Subject: FW: Grenfell Tower, Grenfell Road, Refurbishment - Fire Strategy P2

The Building Regulations 2010 [as amended]
Grenfell Tower, Grenfell Road. London. W11.

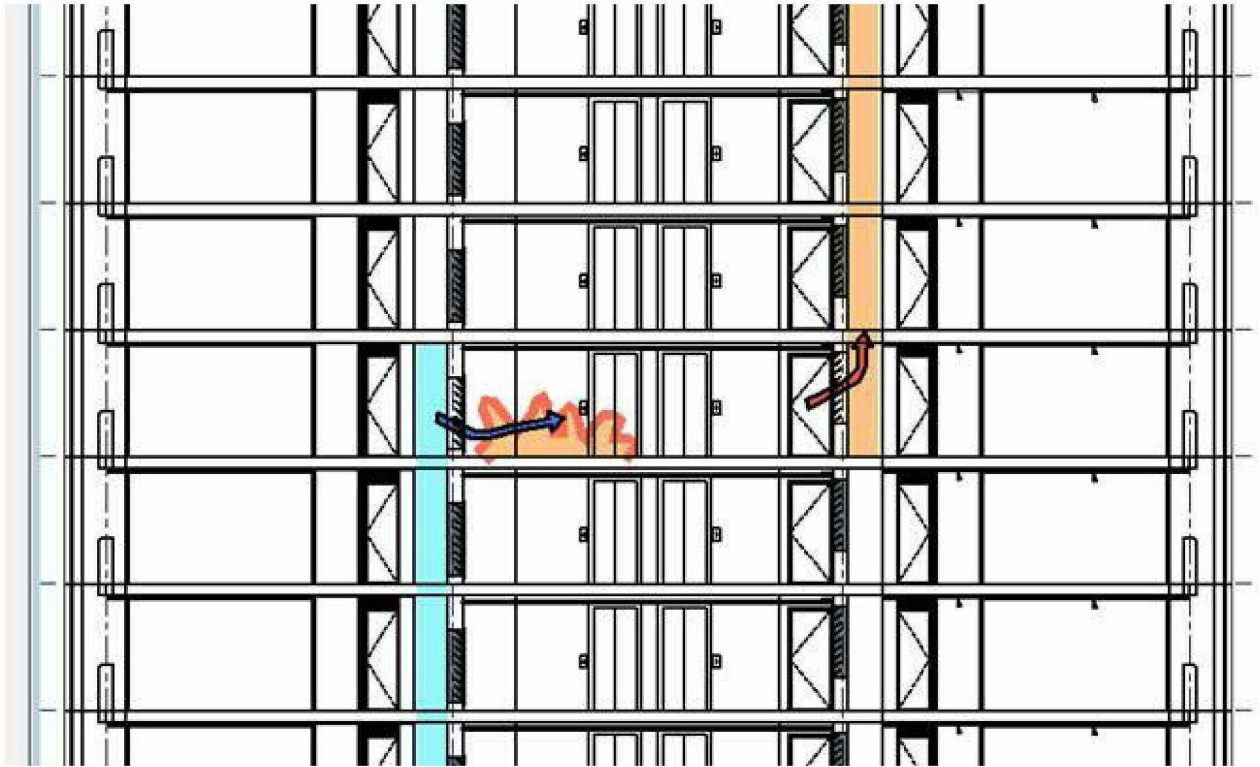
1. “..is designed .. as a natural ventilation system...” (line 2) is followed by “a mechanical supply and extract system which does not rely on natural ventilation” (Smoke Control, second para). His initial response is that this reads like we are omitting a compliant natural vent shaft. **We could just leave the 'compliant' system as it is at present, but we (and Exova) think it would be better to provide a more predictable system with mechanical supply and extract as the default mode, all as described in the 'Proposed System' part of our report.**

2. Some diagrams would be useful. **I have attached our schematic drawing and Studio E have provided the visual representation below.**

3. Principle of dual use of duct for vent and smoke okay – but not clear from document and would like some detail as to how this will be achieved.

The smoke controls and the temperature controls would all be part of the same control system controlling the dampers and the supply and extract fans.

Under normal conditions, all the dampers would be open and the system would operate as a natural ventilation system. Temperature sensors would be located on 'typical' (say 5 No.) lobbies. If the temperature in any of these areas exceeded a pre-set comfort level, then the supply and extract fans would operate to try to reduce the temperature.

In the event of smoke being detected within any lift lobby served by the smoke control system, the fresh air and smoke dampers serving that particular lobby would remain open and the supply and extract fans would operate. The fresh air and smoke dampers on all other levels would be closed. The system would be set up such that it was 'fail-safe' with priority always being given to the fire safety operation.
